SUNDRY NOTICES AND REPORTS ON WELLS

ConocoPhillips Company requests to change the cathodic protection for this well from cable to solar.

CATHODIC PROTECTION PLAN FOR NEW WELLS

Property : SAN JUAN 30-5 UNIT Well #: 269

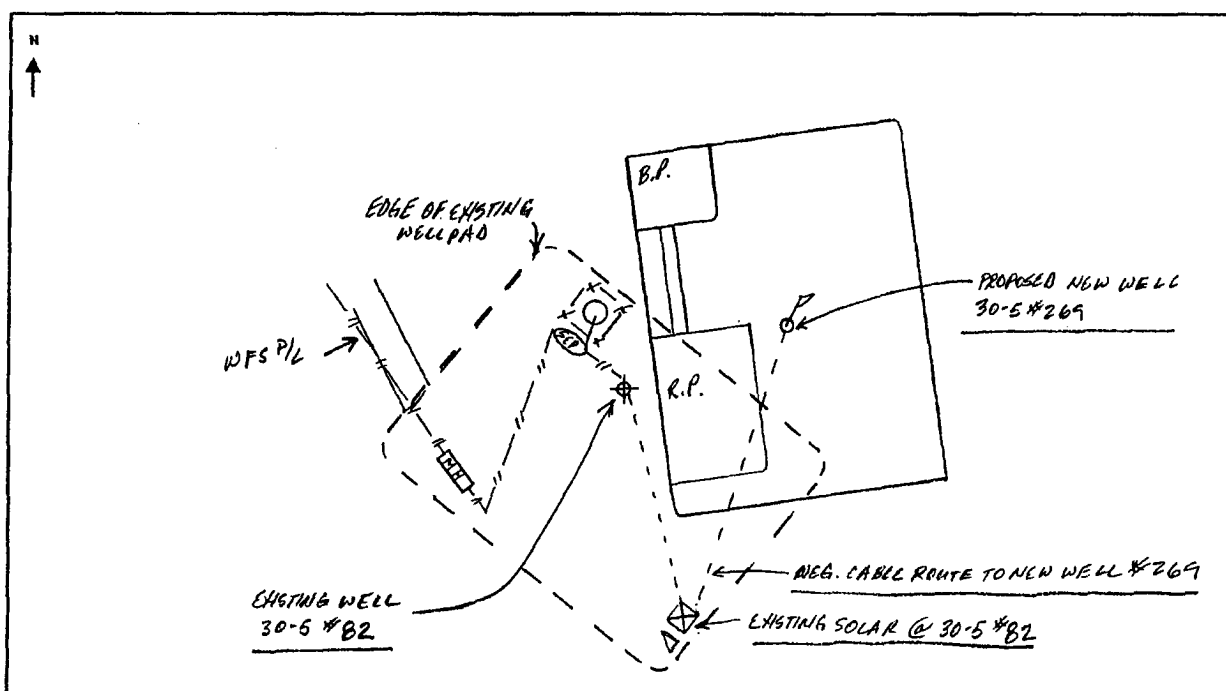
PURPOSED C.P. SYSYTEM: DRILL NEW G.B. & TIE NEW WELL INTO EXISTING SOLAR UNIT @ 30-5 #82.
TRENCH @ 275' OF "B" NEG FROM SOLAR TO RECT.

NEAREST POWER SOURCE SOLAR UNIT @ 30-5 #82 DISTANCE: 275'
 PIPELINES IN AREA: 1 - WFS @ M.O. OF #82 M.H.
